City of Portland, Maine - Building or Use Permit Application 389 Congress Street, 04101, Tel: (207) 874-8703, FAX: 874-8716

BUILDING PERMIT REPORT

DATE	: 80CT 98 ADDRESS: 591 IS. Ave. P.I. CBL \$85-J-92
	ullet
	ON FOR PERMIT: INSTALL NEW FLOOR SYSTEM
BUILI	DING OWNER: Bragdon
	TRACTOR: John Kiely
PERM	IIT APPLICANT:
	group $R-3$ boca 1996 construction type $5B$
	CONDITION(S) OF APPROVAL
	Permit is being issued with the understanding that the following conditions are met:
Appro	oved with the following conditions: * 1, *8, *10, *24, *26, *29 * 31 # 28

PERMIT 981157
PROJECT

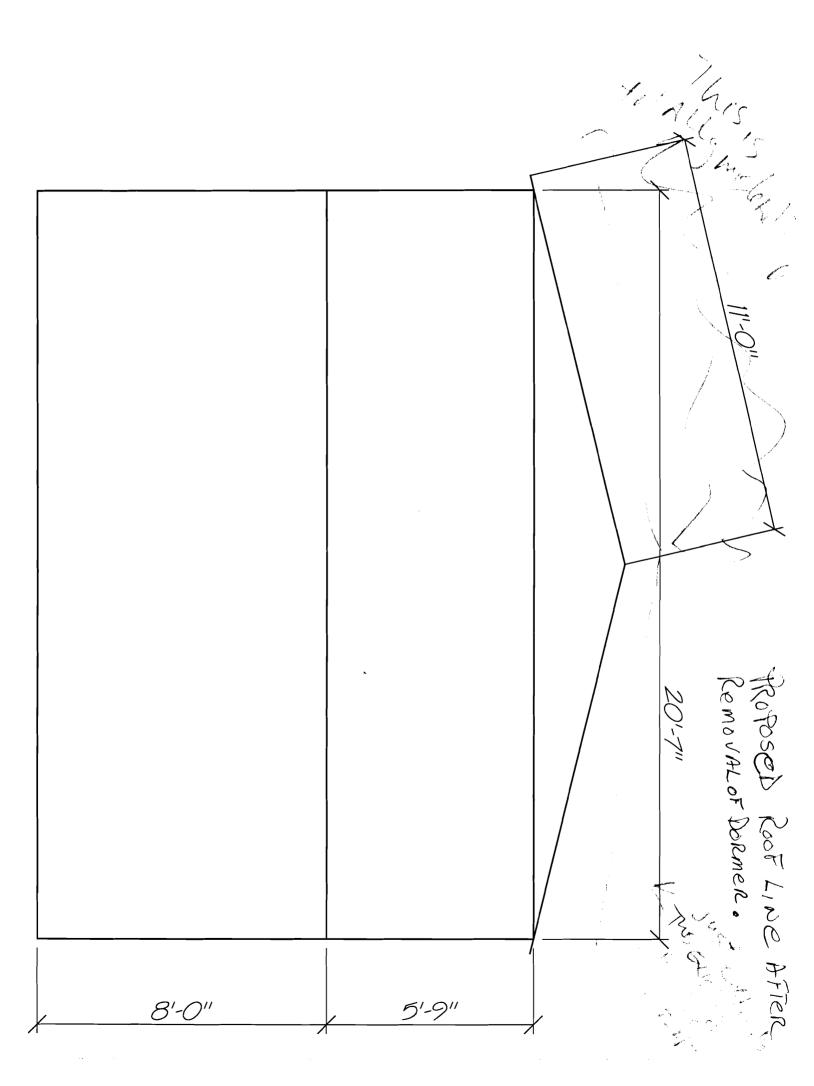
30.	Glass and glazing shall meet the requirements of Chapter 24 of the building code.
X 31.	Glass and glazing shall meet the requirements of Chapter 24 of the building code. Your Submitted plan did NOT Show The MICROLOMS JOIST SIZE - Please
, `	Submit This info, before work is started-
32.
